STAGE 1 ROAD SAFETY AUDIT REPORT FOR ACTIVE TRAVEL IMPROVEMENTS BETWEEN MEADOWS AND GEORGE STREET, EDINBURGH.

Report Ref 114421(1)

Issue Date 17-Dec-21

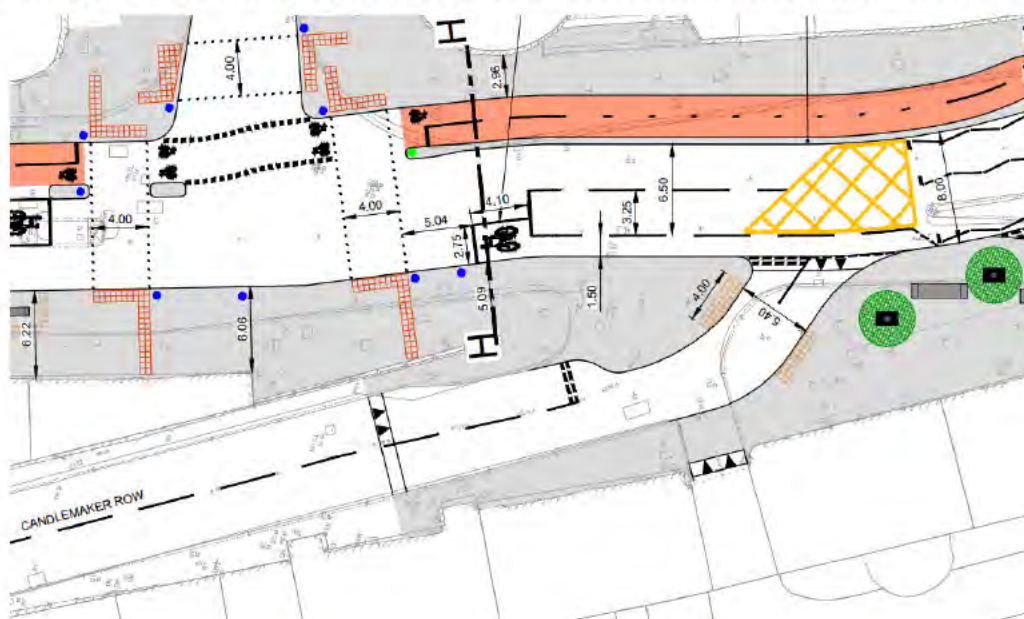
5.3 PROBLEM

Location Hanover Street.

Summary Risk of injury to wheelchair user from a fall.

Segregation islands separate the bus, loading and taxi bays from the cycleway and footway. Drop kerbs with tactile paving is provided for bus passengers to cross the cycle lane onto the segregation island, however no similar provision is shown for wheelchair users to access the taxi bays or delivery drivers who will push goods by barrow. The lack of drop kerbs to provide safe access to the segregation islands may result in wheelchair users toppling out of their chair and sustaining injuries from a fall.

It is recommended that drop kerbs are provided at all taxi and loading bays to allow wheeled access to the segregation islands.
